World Forum for Harmonization of Vehicle Regulations

Proposal for Supplement 1 to the 03 series of amendments to UN Regulation No. 67 (LPG vehicles)

Submitted by the Working Party on General Safety Provisions *

"Figure 3

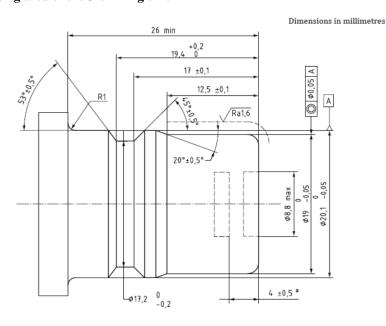
Figure 3, amend the figure title to read:

Connecting area of the K15 filling unit"
